**George Vanderheyden**  
Vice President  
Calvert Cliffs Nuclear Power Plant  
Constellation Generation Group, LLC

**SUBJECT:** Calvert Cliffs Nuclear Power Plant  
Unit No. 1; Docket No. 50-317  
Supplemental Data for Request for Relaxation from Interim Inspection  
Requirements for Reactor Pressure Vessel Head (TAC No. MC1921)

**RESPONSE TO REQUESTS FOR ADDITIONAL INFORMATION**

Figure 1: Illustration of Stress Analysis Mesh Indexed to Node 81401

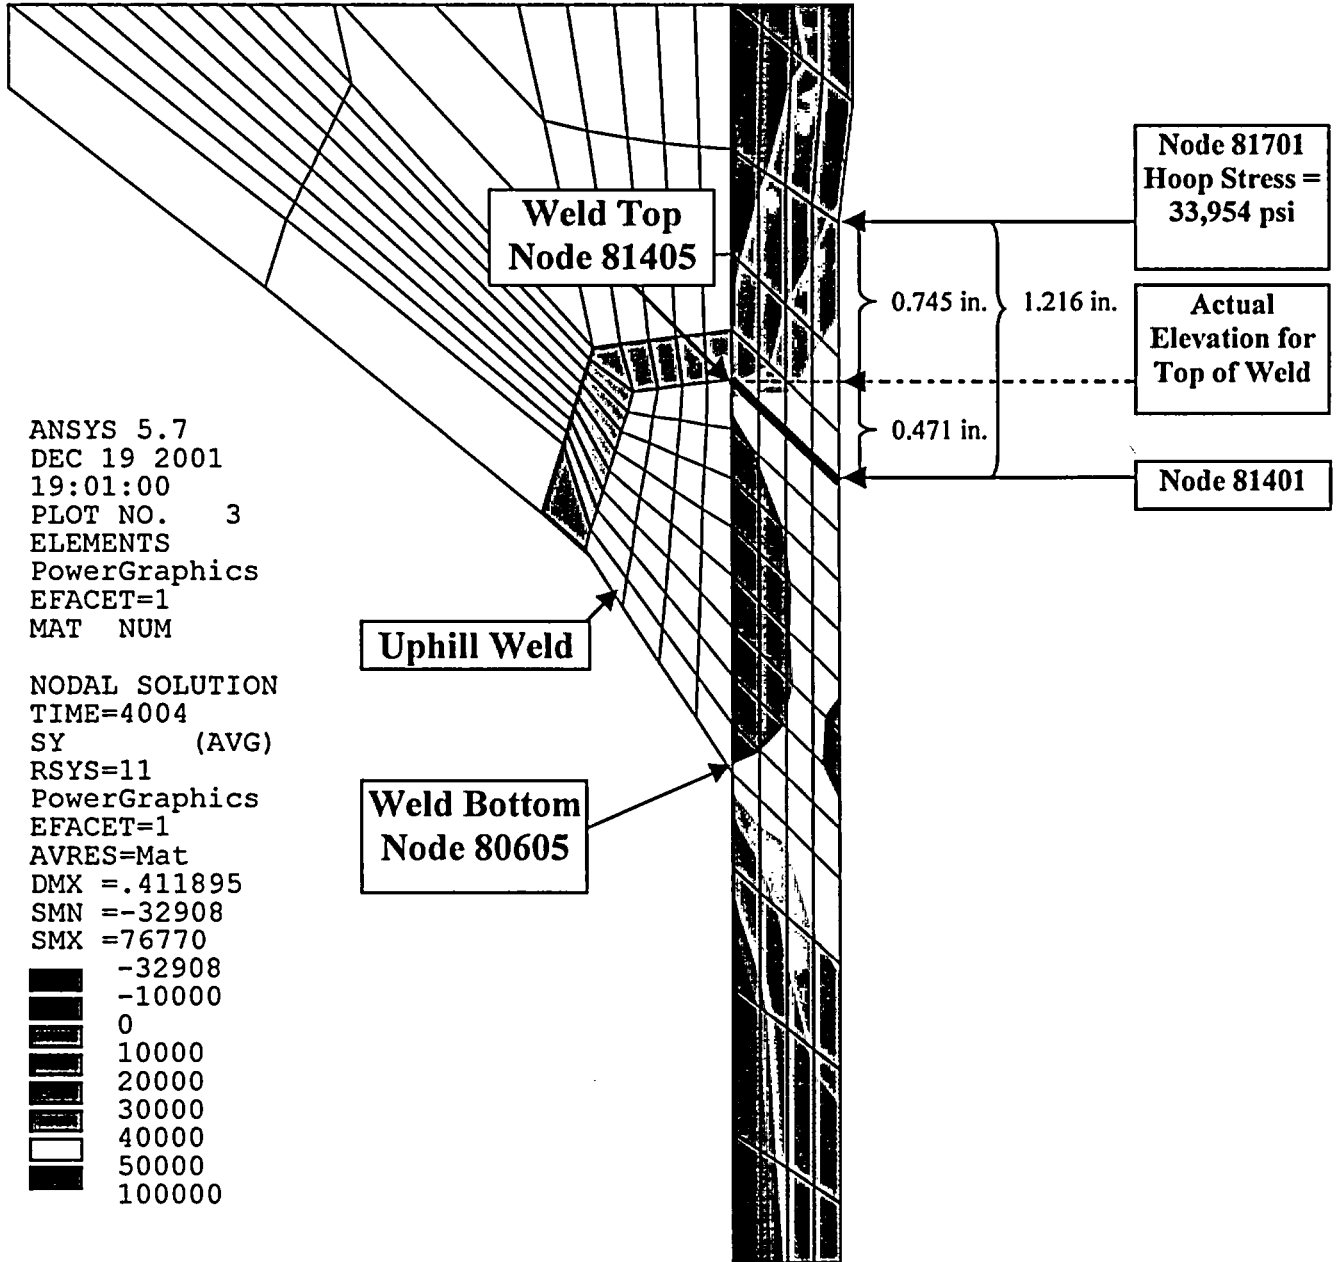
*Explain in detail how the absolute elevations of the top and bottom of the weld were obtained.*

*Provide an example using this methodology. For example, for node 81701 at a 43 degree angle, the distance above the J-groove weld was 1.216 inches and the Hoop Stress calculated in the FEA was 33954 psi.*

*With the updated post-processing method, a nozzle at 43 degrees with a distance of 1.185 inches above the weld has a Hoop Stress calculated at 16.2 ksi. CCNPP needs to justify this huge discrepancy in stress values.*

nodes at the nozzle outside diameter (OD)/weld interface. The bottom of the weld is the lowest node along this interface and the top of the weld is the highest node along this interface. Please refer to Figure 1 where the top and the bottom of the weld for the uphill weld are identified for the 43 degree angle model.

The discrepancy in stress values between the 2003 relaxation request and the 2004 relaxation request is due to a conservative simplification of the model geometry used in 2003 to calculate stresses above the top of the weld at the uphill side. Figure 1 is a plot of the operating hoop stresses at the uphill side of the 43 degree nozzle. The nodes at the top and bottom of the weld are identified, as are nodes of interest on the inside diameter (ID) side of the nozzle.

As shown in the table, nodes 81405 (on the OD) and 81401 (on the ID) were both assumed to be at the same absolute elevation (shown in bold). In fact, node 81405 is at the elevation of the weld root, but node 81401 is below the elevation of the weld root as shown in Figure 1 (by the bold line). In 2003 we reported the stresses on the nozzle ID surface at various distances with respect to 81401 instead of with respect to 81405. The assumption that 81401 and 81405 were at the same elevation simplified the determination of stresses, but provided values that were conservatively high.

The stress at node 81701, which is 1.216 inches above node 81401, is 33,954 psi. The stress at this node in 2004 is that same as it was in 2003. As shown in Figure 1, this stress value agrees with the stress contours of the hoop stress plot.

In 2004, it was decided to report ID stresses in reference to the location of the top of the weld. As shown in Figure 1, node 81701 is actually only 0.745 inches above the top of the J-groove weld.
